Memorandum
Department of Planning and Development
Planning Division

To: Chair Delogu and Members of the Portland Planning Board
From: Rick Seeley, Senior Planner, GPCOG
Date: April 27, 2004
Re: **Maine Medical Center Contract Zone**
Building Addition, Helipad, Parking Garage, and Central Utility Plant
Vicinity of Bramhall, Charles, Wescott, Ellsworth, Crescent,
Gilman and Congress Streets

Responses to Planning Board Issues Since the March 23rd Workshop

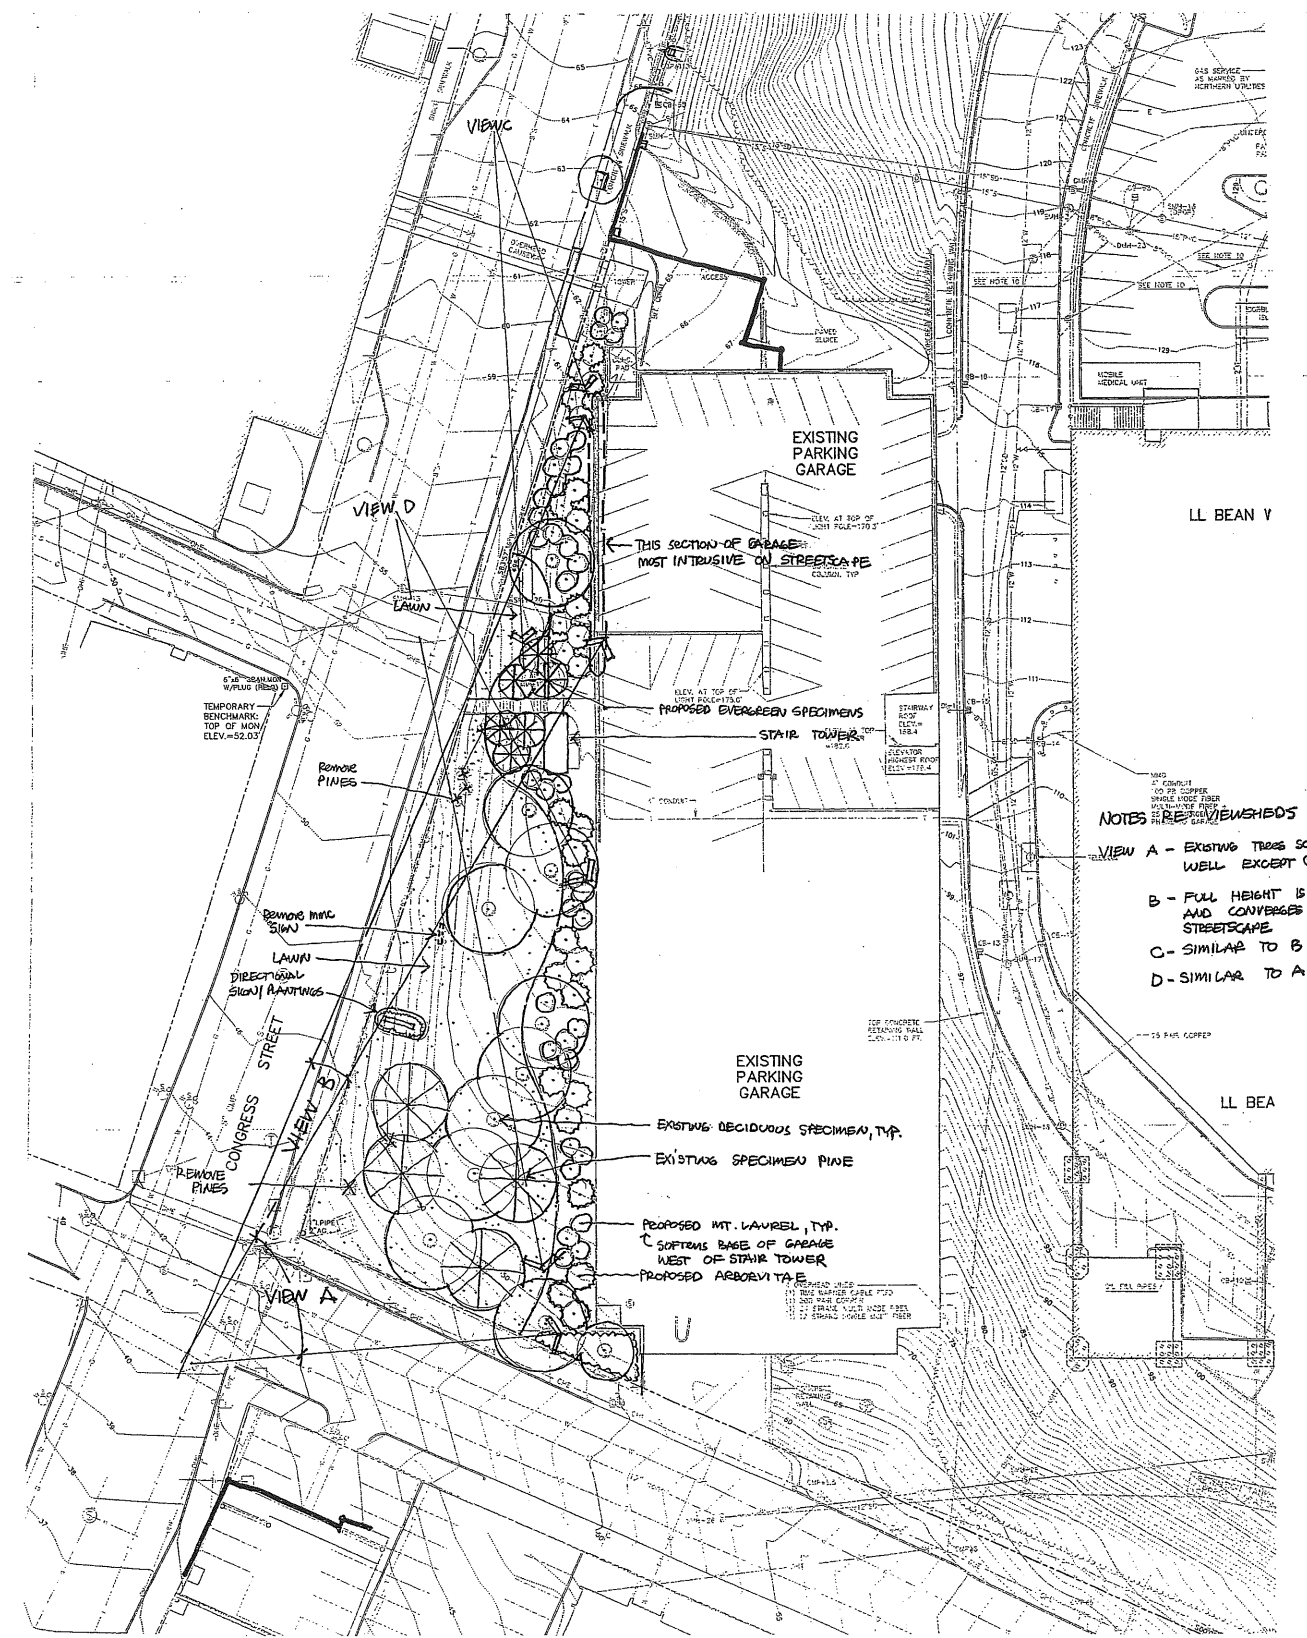
NOTES TO BE REVIEWED

- VIEW A - EXISTING TREES SCREEN GARAGE WELL EXCEPT @ BASE
- B - FULL HEIGHT IS VISIBLE AND CONVERGES UPON STREETSCAPE
- C - SIMILAR TO B
- D - SIMILAR TO A
